SEWAGE DISPOSAL SYSTEM

DEPARTMENT OF HEALTH AND MENTAL HYGIENE INDEXED

SUBDIVISION Kings Gift LOT 34 ROAD 11541 EAST WINCHESTER LANE
~~11732 Frederick Road~~

RE: BP # B00109717, Proposed Garage
BP # B00109571, Proposed 4BR Dwelling
King's Gift, Lot 34
11732 Frederick Road

SEPTIC TANK CAPACITY 1000 GALLONS TOP SEAMED GARAGE - PUMPED SEPTIC SYSTEM
INSTALL: 1000 Gallon Pump Pit Top Seamed

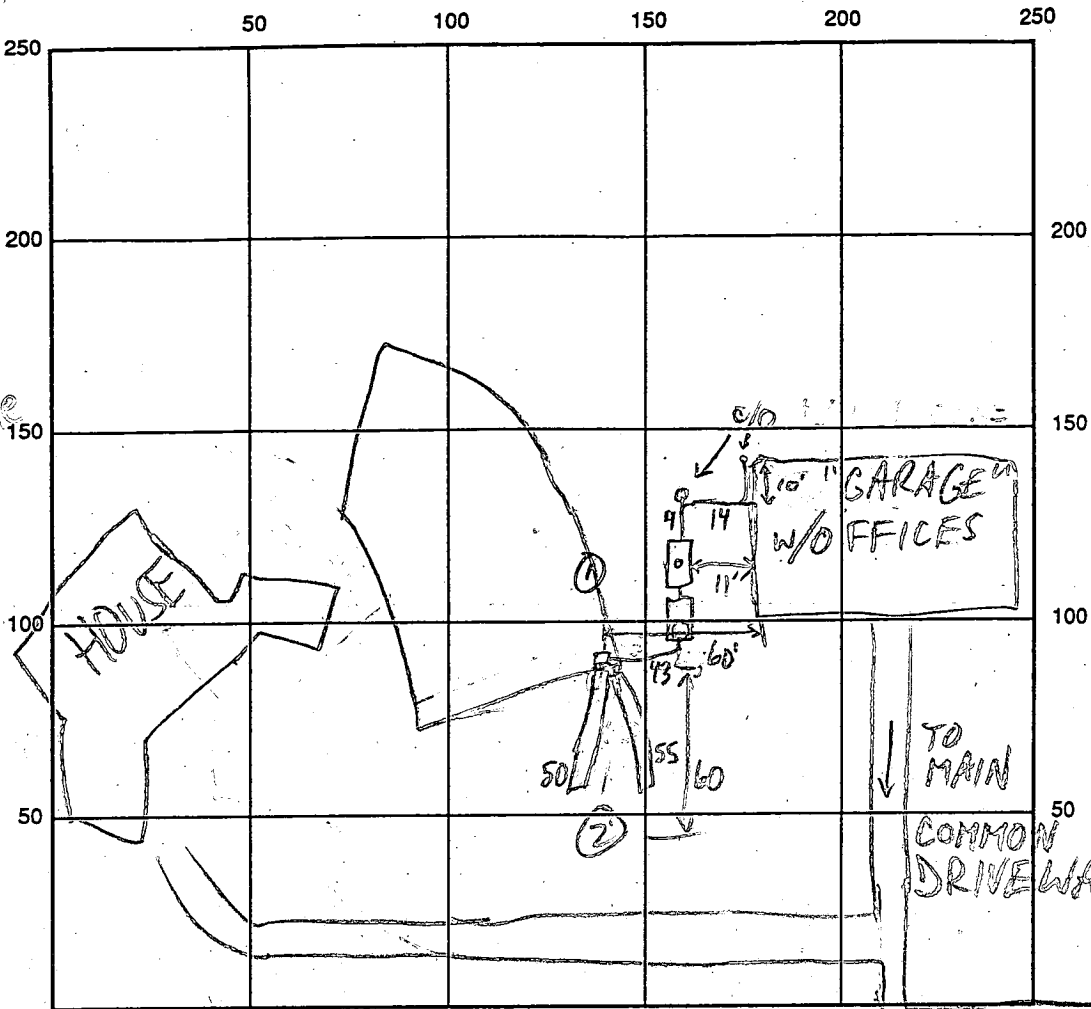
REMARKS: 4/28/98 "GARAGE" IS ACTUALLY OFFICE BLDG (~8 EMPLOYEES) -
STOP WORK (MR) 5/4/98 OK TO CONTINUE (BLDG OK); PERC HOLE ①
DUG FOR H₂O TABLE - OK; PERC HOLE ② @ OWNER'S REQUEST - OK TO
EXPAND SYSTEM (MR) 5/5/98 TRENCH RUNNING UPHILL - STOP WORK MR
5/6/98 TRENCH LOC. & DESIGN APPROVED CW/MR 5/7/98 PUMP & ALARM -
OK (MR)

LOCATION - Place distribution box at the center of the lowest edge of the septic easement. Run trench on contour toward driveway access.

LOCATION DRAWING

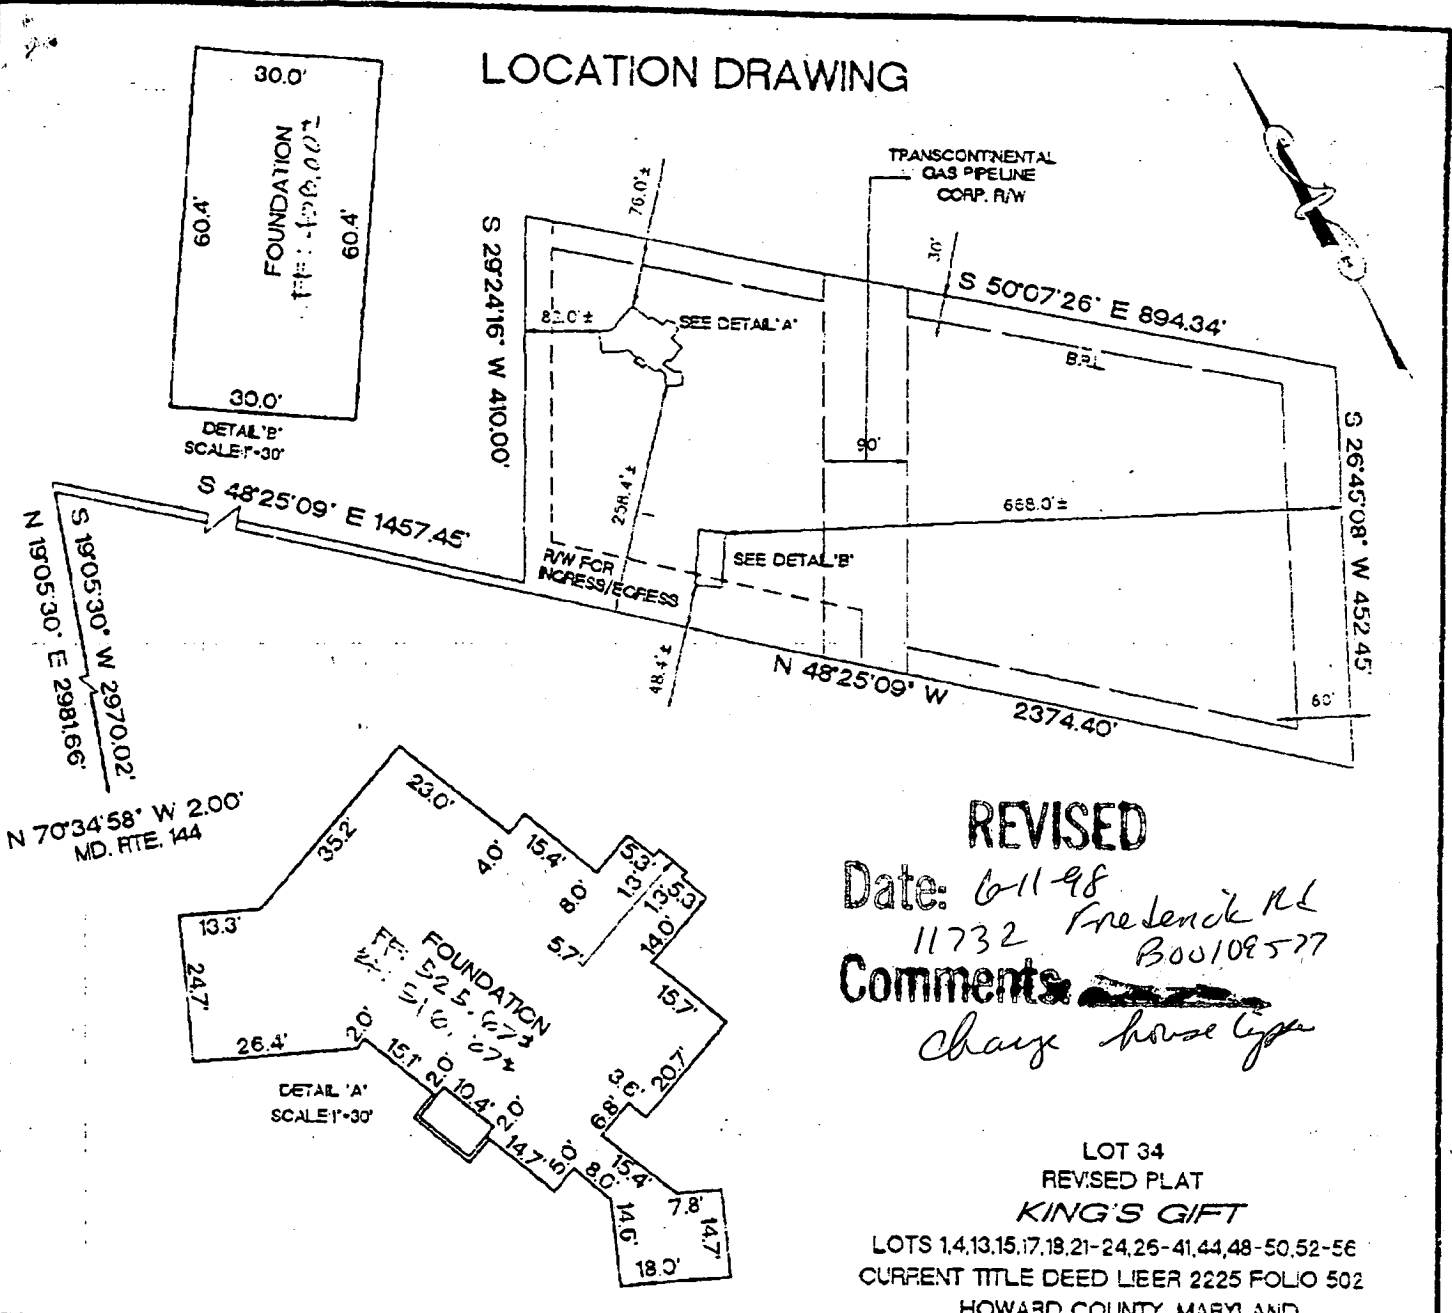
Please accept the attached revised plans and location survey for the above permit. We have extended the foot print as noted on both the revised plans and location survey.

Date: 6-11-98
 11732 Frederick Rd
 Comments: ~~Change house type~~
 BOO108577
 Change house type

SITE GRADING PLAN KING'S GIFT (LOT 34)

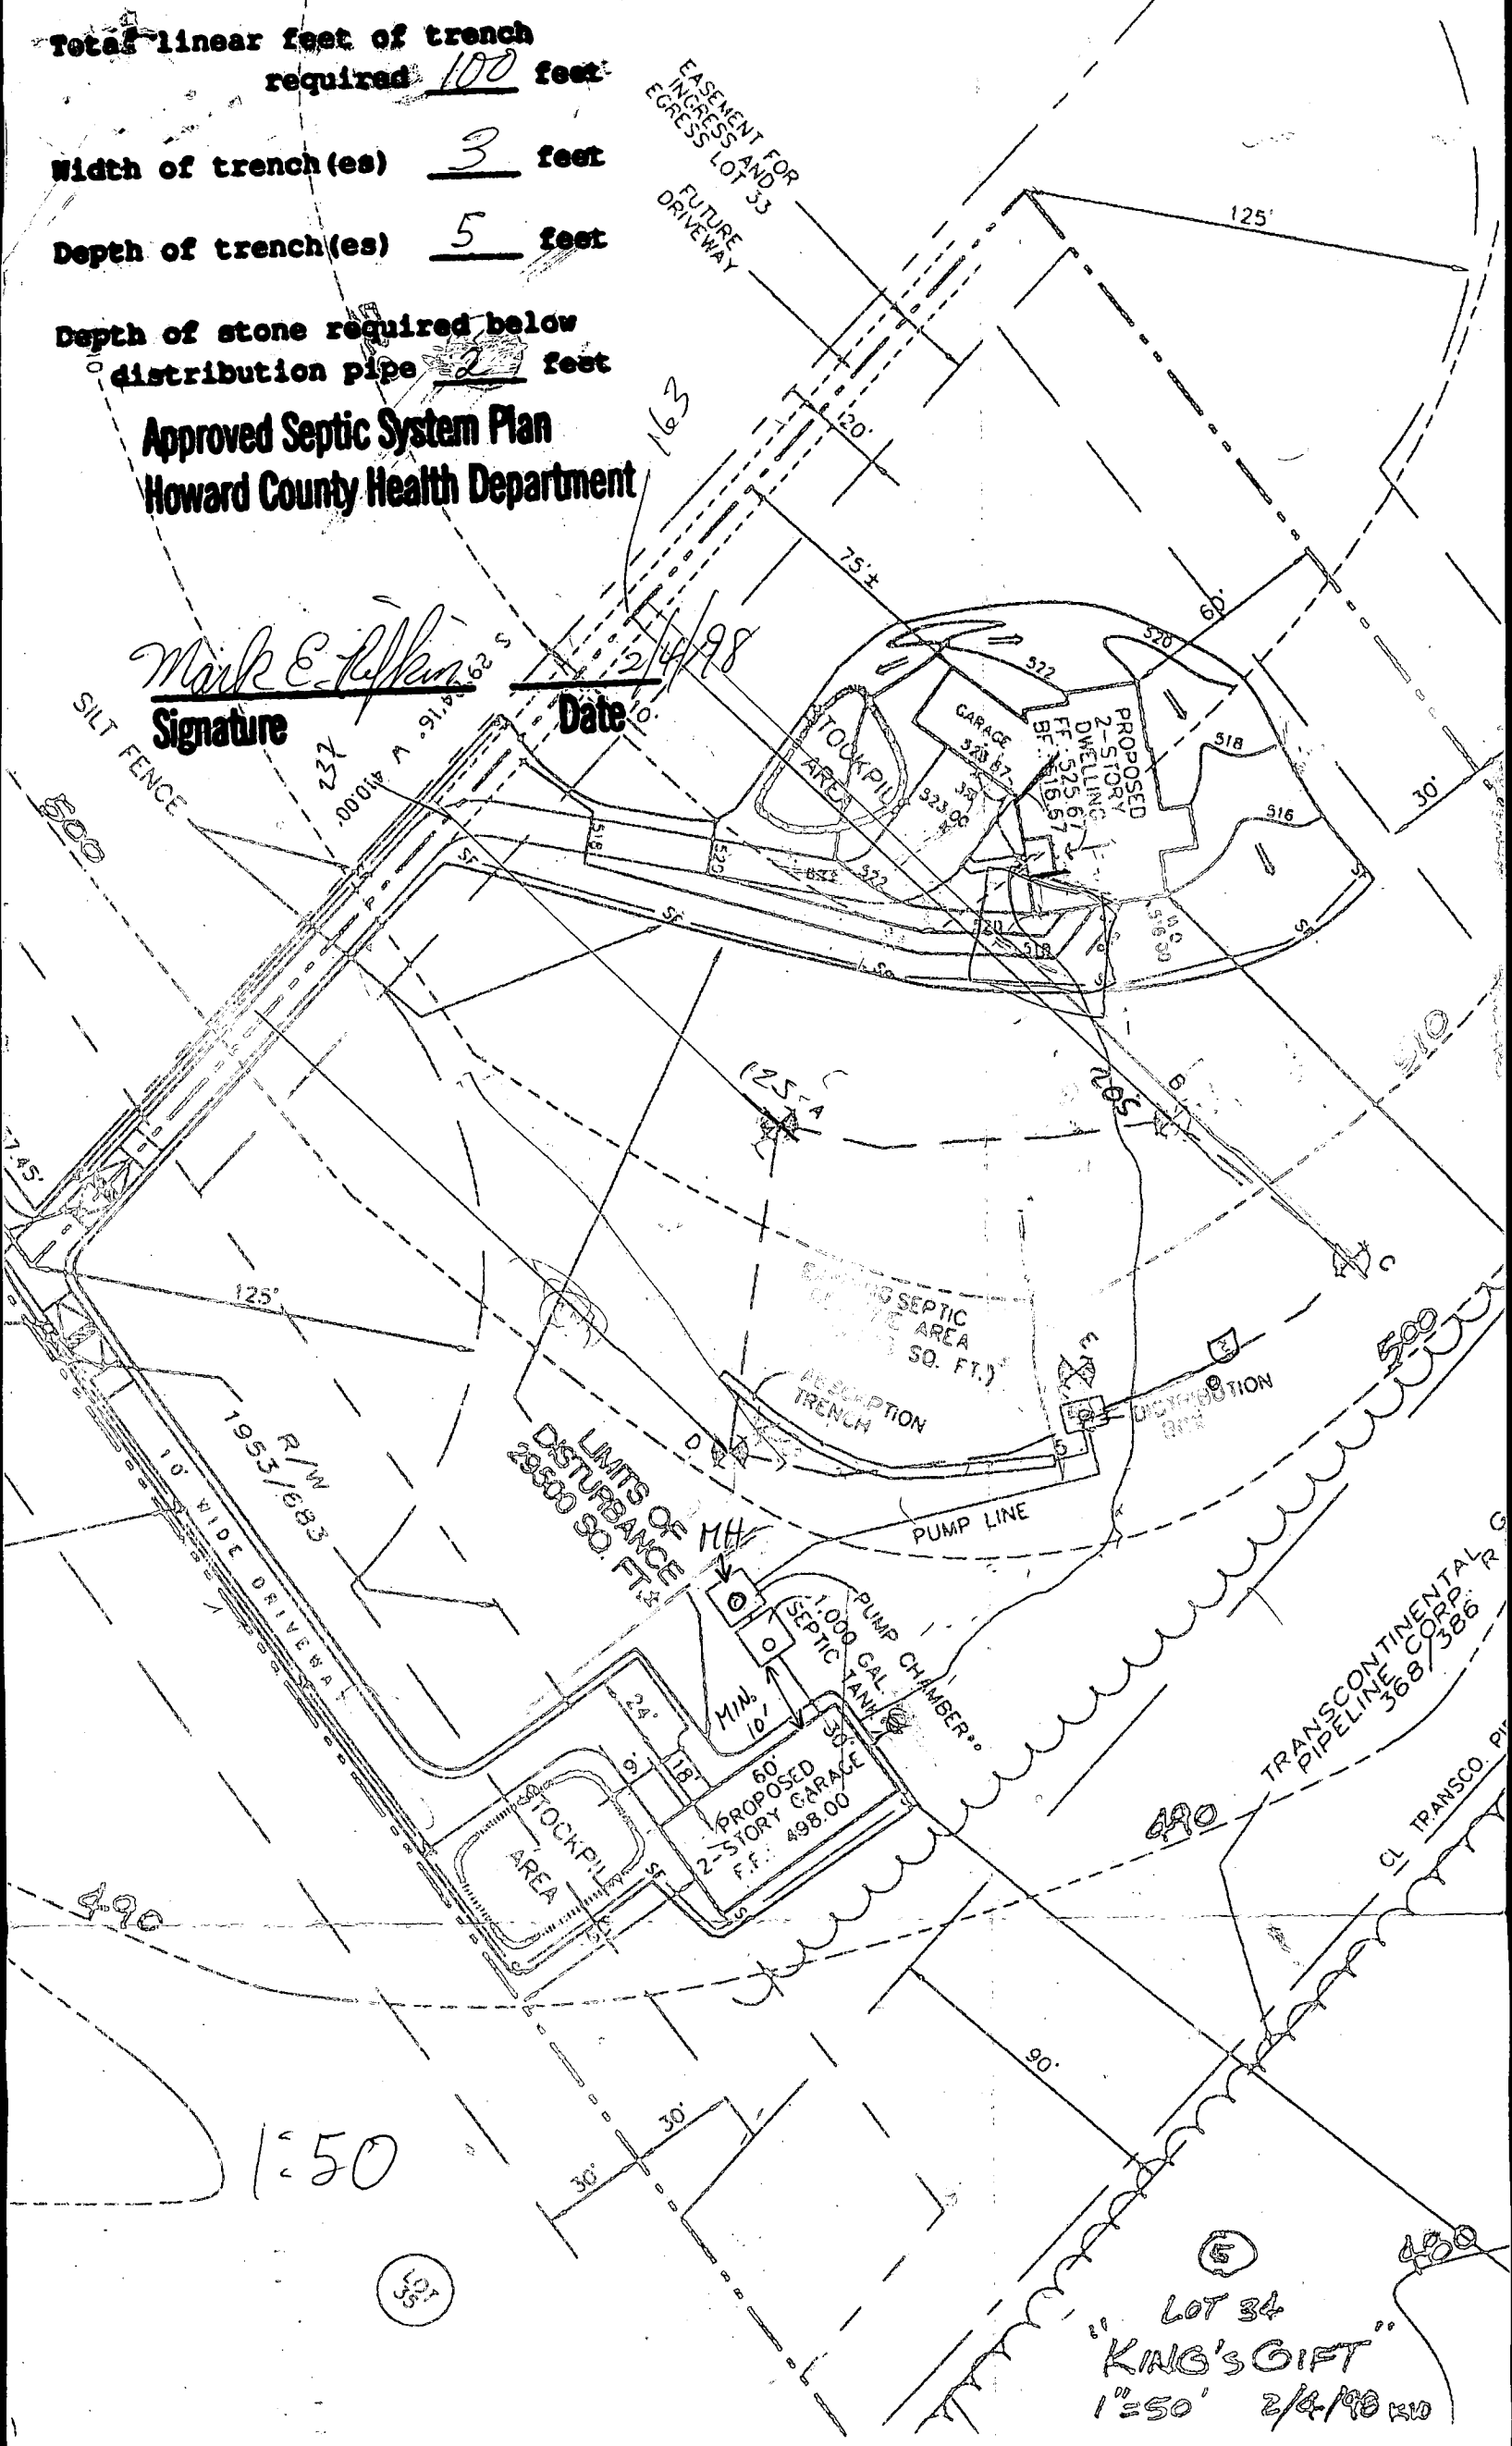
5	02/03/98	ADDED GARAGE SEPTIC SYSTEM REMOVED SEPT. SYS. FOR HOUSE(+)	KW	SCALE: 1" = 50'
					DATE: October 28, 1997
	4	02/03/98	REV'D SEPTIC LAYOUT & CHART FOR HOUSE	KW	JOB NO.: 97165
					DESIGNED:
	3	07/31/98	ADDED SEPTIC SYS. & ELEV. CHART FOR HOUSE	KW	DRAWN: KP
					CHECKED: RM
	2	01/21/98	REVISED L.O.D. TO MAX. OF 30000 SQ. FT.	SLD	FILE: 97165SS2.DWG
					DRAWING NUMBER:
BE	1	12/31/97	ADDED SED. CON./L.O.D	SLD

Total linear feet of trench required 100 feet

Width of trench(es) 3 feet

Depth of trench(es) 5 feet

Depth of stone required below distribution pipe 2 feet

SITE GRADING PLAN KING'S GIFT (LOT 34)

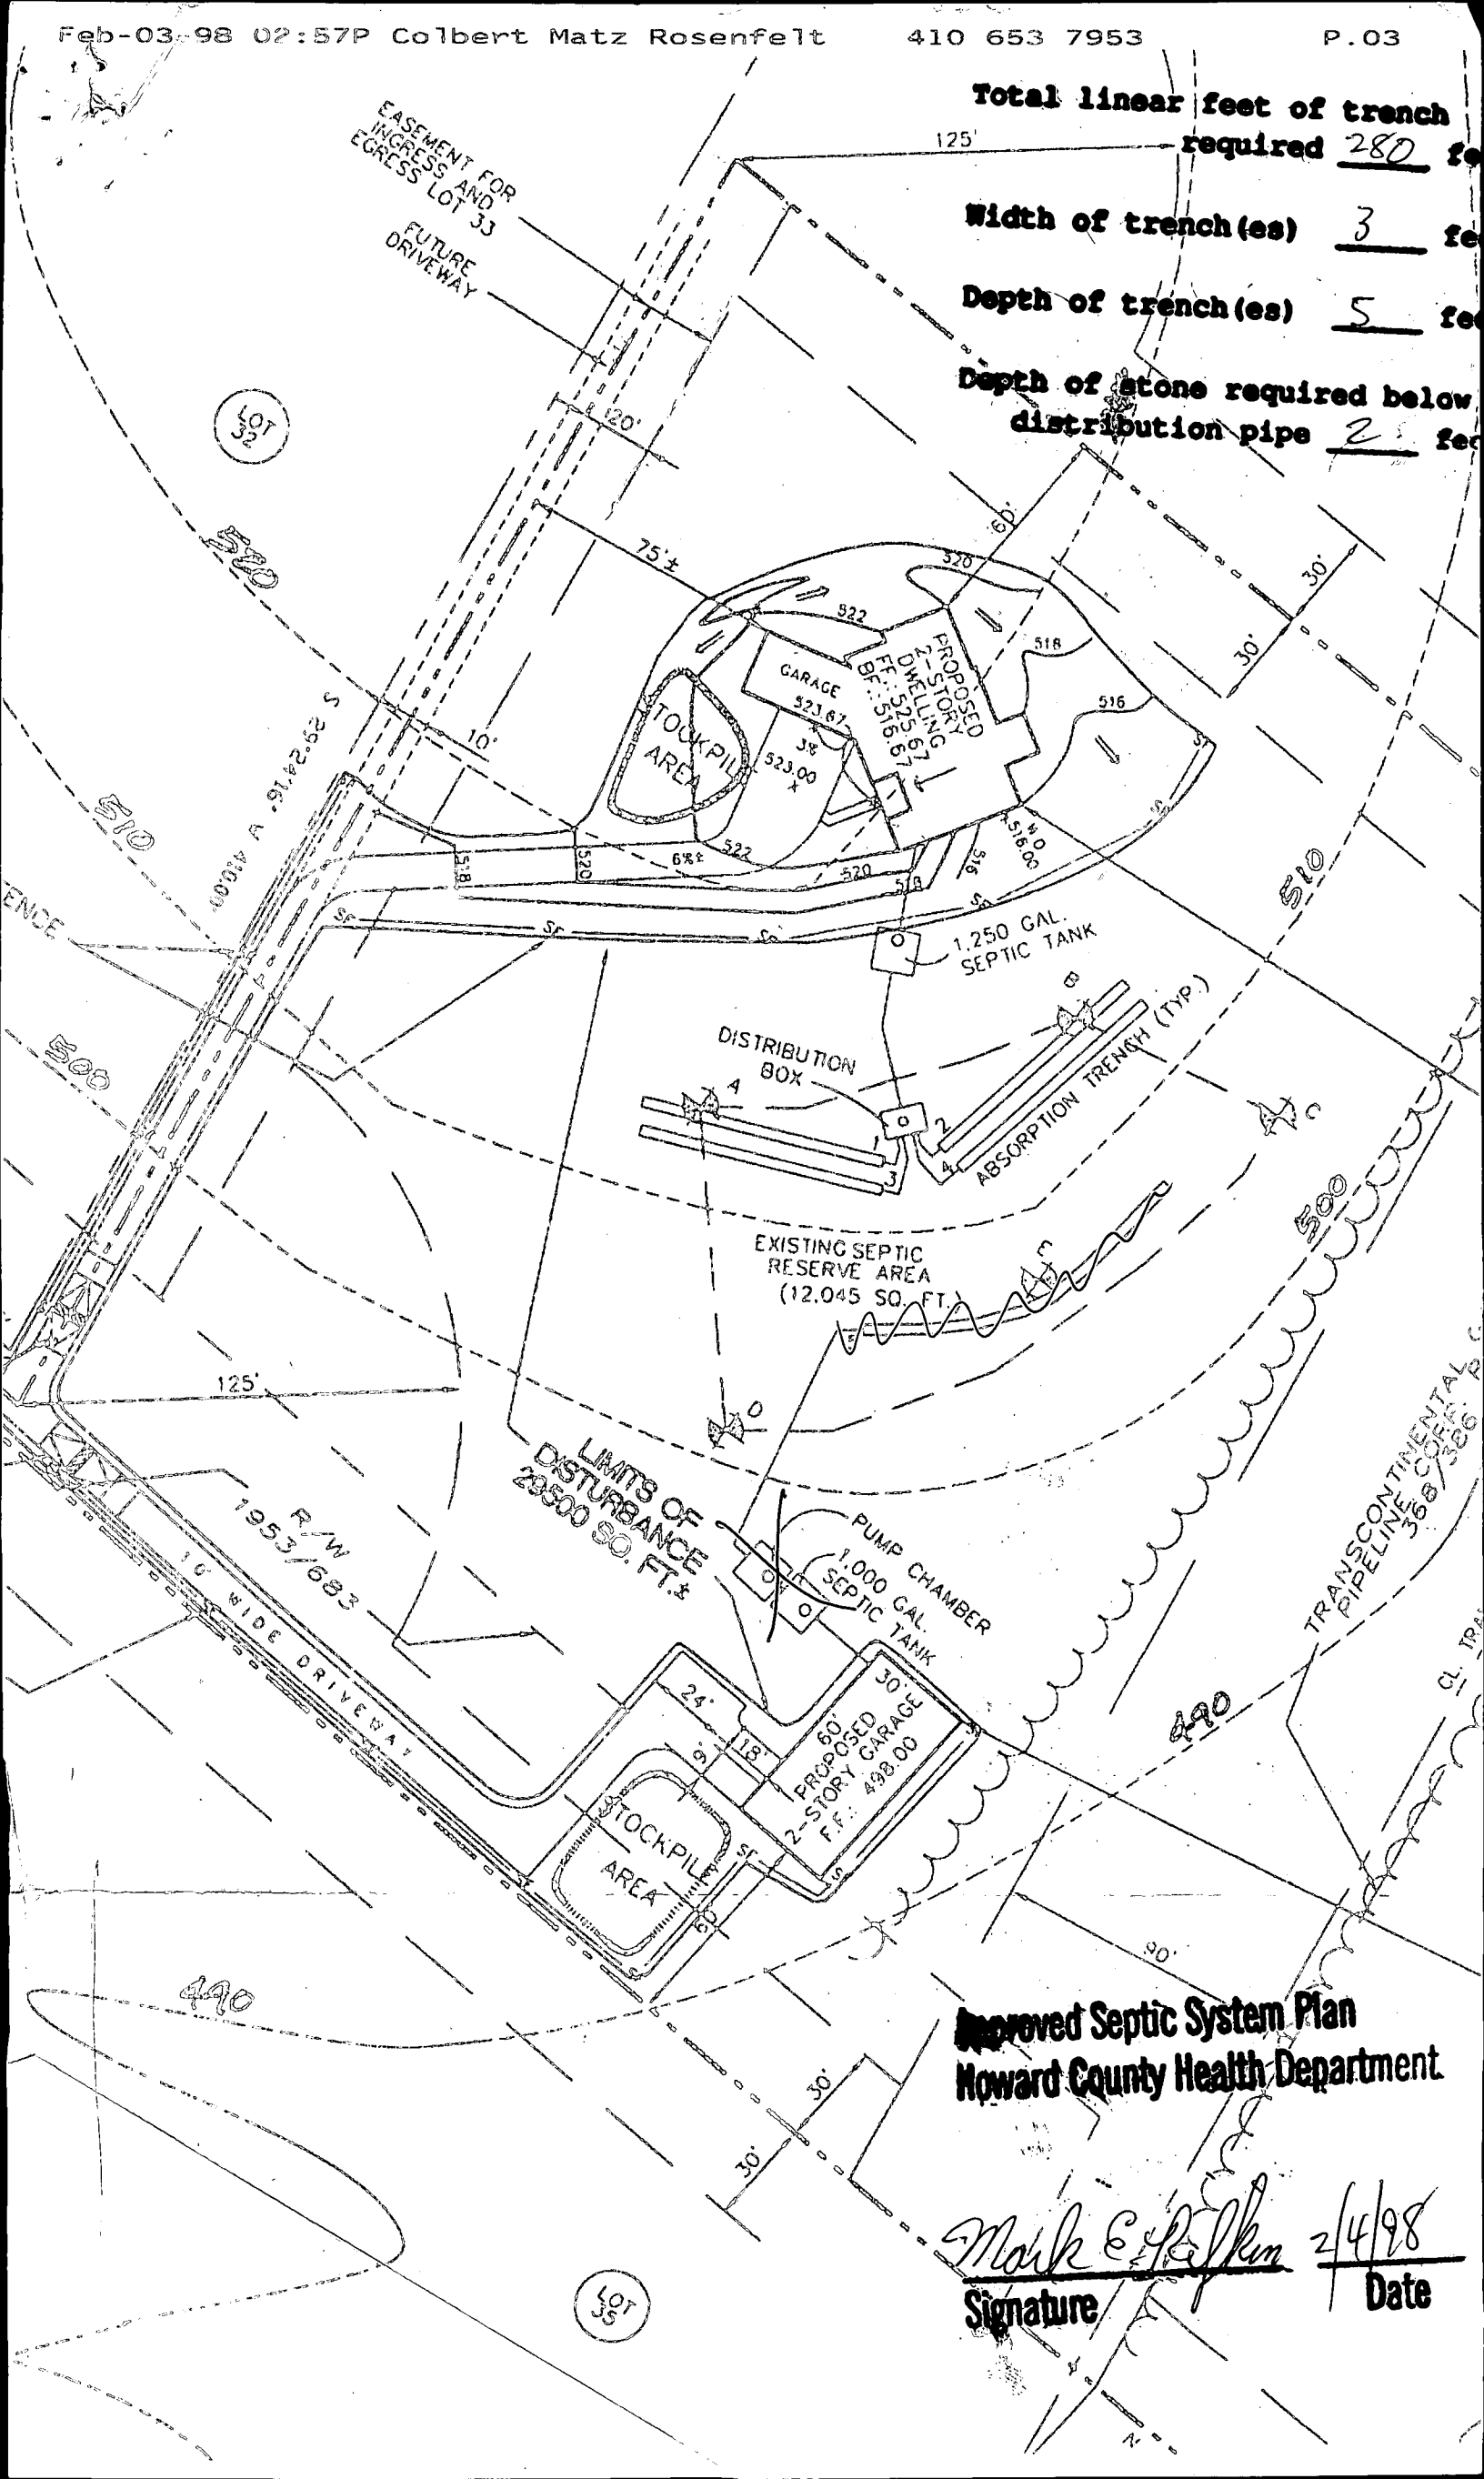
SCALE: 1" = 50'
				DATE: October 28, 1997
				JOB NO.: 97165
				DESIGNED:
				DRAWN: KP
				CHECKED: RM
3	01/30/98	ADDED SEPTIC SYS. & ELEV CHART	KW	FILE: 97165SIT.DWG
2	01/21/98	REVISED L.O.D. TO MAX. OF 30000 SQ. FT.	SLD	DRAWING NUMBER:
1	12/31/97	ADDED SED. CON./L.O.D.	SLD	
NO	DATE	REVISIONS:	BY	SHEET 1 OF 1

Total linear feet of trench required 280 feet
 Width of trench (es) 3 feet
 Depth of trench (es) 5 feet
 Depth of stone required below distribution pipe 2 feet
